# **REVISED/ADDITIONAL DOCUMENTATION PART 9**

**2017SSH019**

**DA17/0467**

**1-21 Dillwynnia Grove, Heathcote**

### 4) Landscaping: *Tree 78*

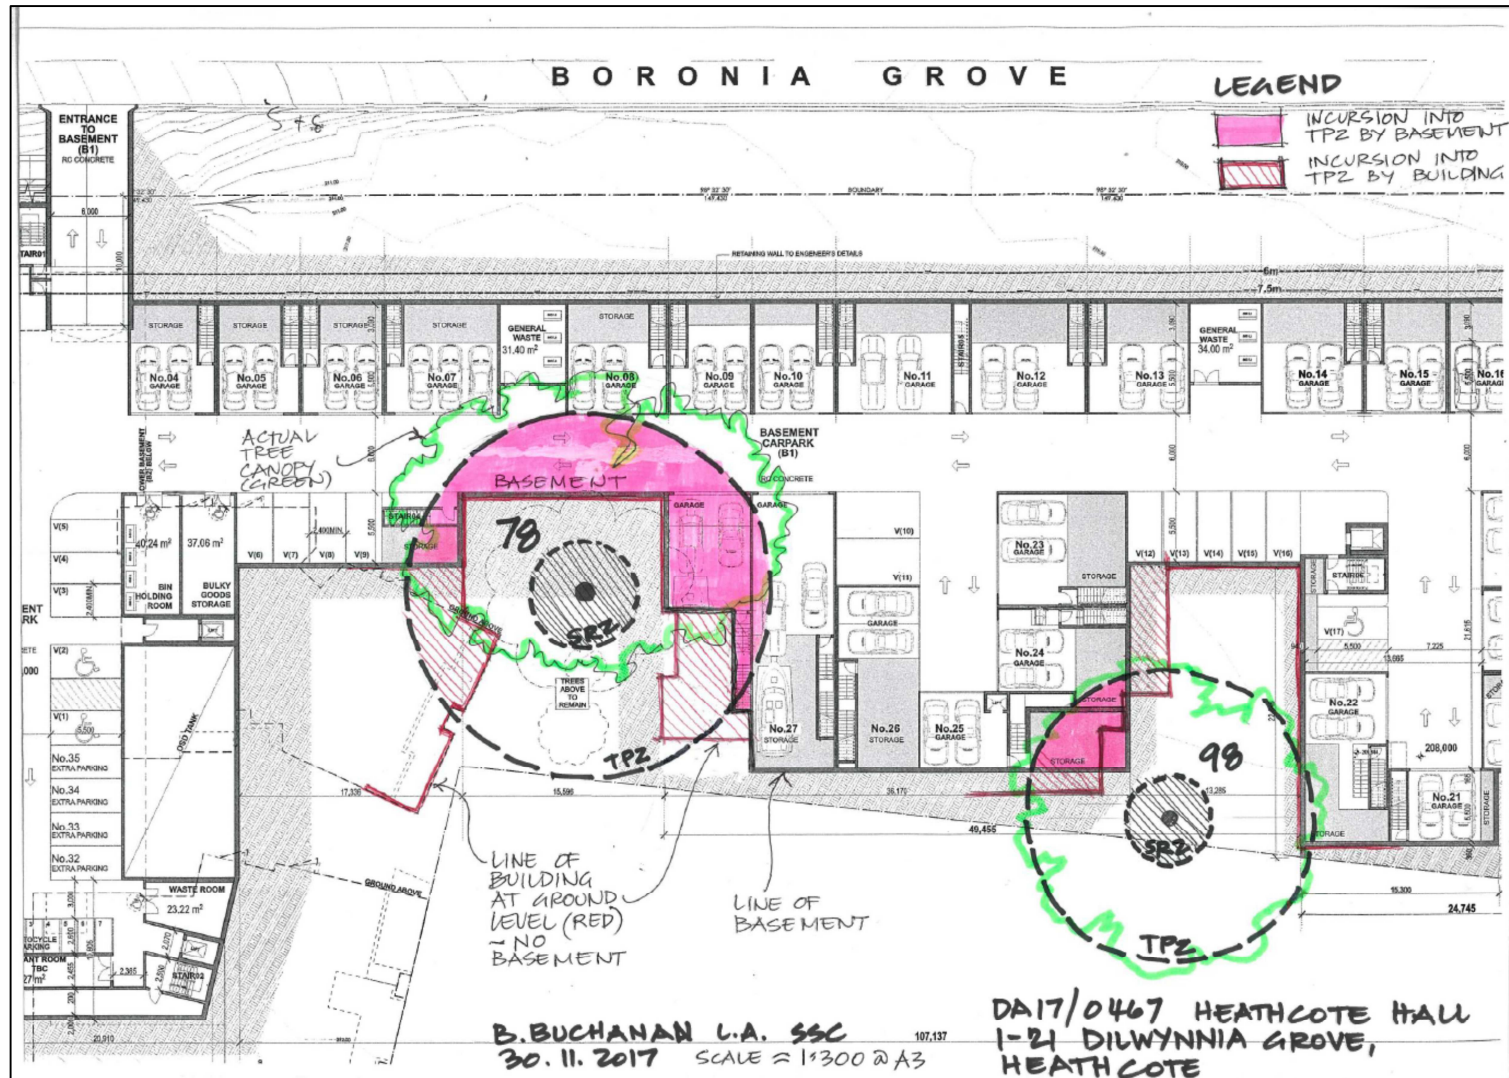
Councils Landscape Architect has provided a hand marked drawing regarding trees 78 and 98 below (*by B Buchanan L.A. SSC, Date 30 November 2017*).
